Document Number: <u>CY-OC-170-301</u>		Revision: <u>2</u>	
Title: <u>Offsite Dose Calculation Manual for Oyster Creek Generating Station</u>			
<input type="checkbox"/> New	<input type="checkbox"/> Cancel Document	<input type="checkbox"/> Cancel Revision	<input checked="" type="checkbox"/> Revision
EC#: _____		PCR#: _____	PPIS#: _____
<input type="checkbox"/> Editorial		ER#: _____	AR#: _____
<input type="checkbox"/> Batch		#: <u>S67226-09-11</u>	
<input type="checkbox"/> Supersede corporate document(s) List: <u>None</u>			
Revision Summary: <u>Attachment 1 of ODCM Summary Matrix (CY-AA-170-3100) has changes</u>			
Attach add'l descript, if req'd			
Impact on Operating and Design Margins: <input checked="" type="checkbox"/> N/A			
Attach add'l descript, if req'd			
CONFIRM that no commitments (i.e., those steps annotated with CM-X) have been changed or deleted unless evaluated via completion of LS-AA-110 commitment change/deletion form and INITIAL [Preparer]: <u>RA</u>

Title: Offsite Dose Calculation Manual for Oyster Creek Generating Station

This activity is a revision of the Oyster Creek ODCM, procedure CY-OC-170-301. The changes are.

FIGURE D-1-2: SOLID RADWASTE PROCESSING SYSTEM

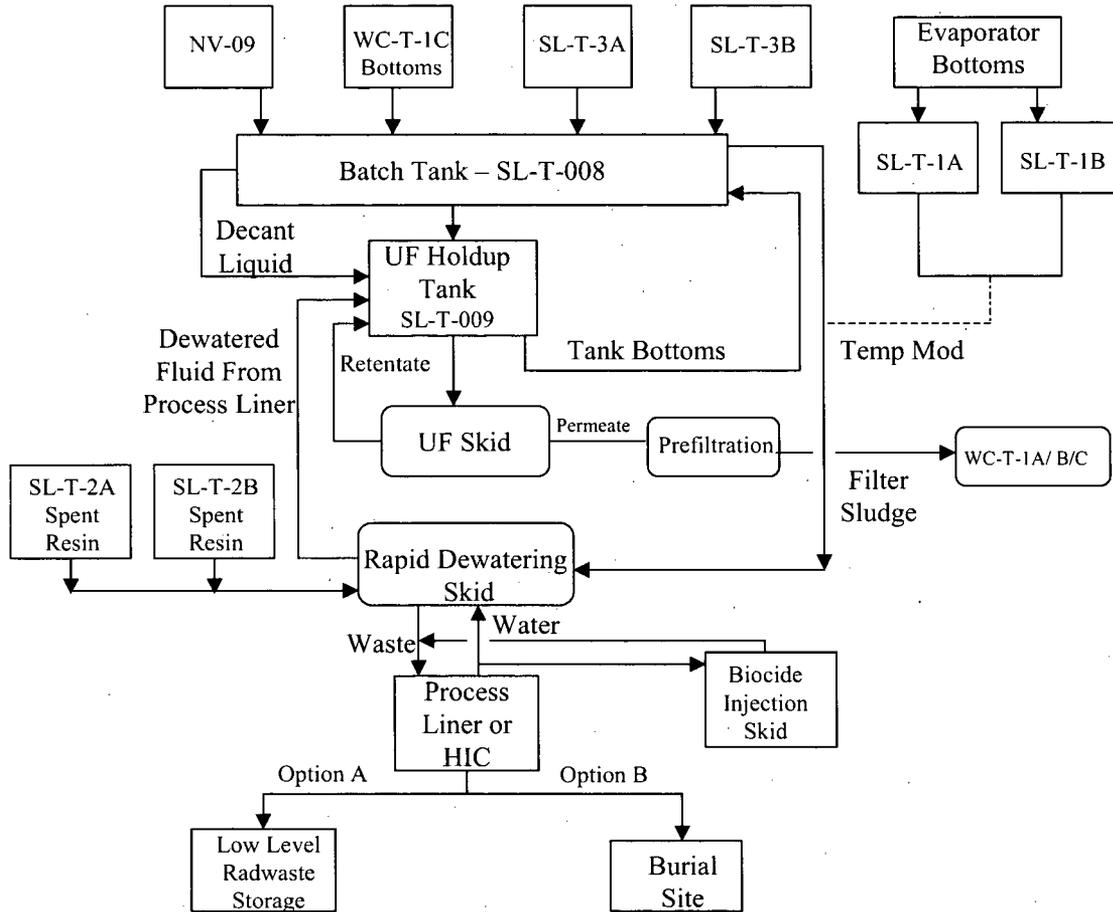
- Updated Solid Radwaste Processing System diagram, Figure D-1-2. Added tanks to drawing.

41.	108	125	A/B	Updated Solid Radwaste Processing System diagram, Figure D-1-2. Added tanks to drawing.
42.	53	60	A/B	Added the words "elevated release" prior "D/Q" in the last paragraph on the page.
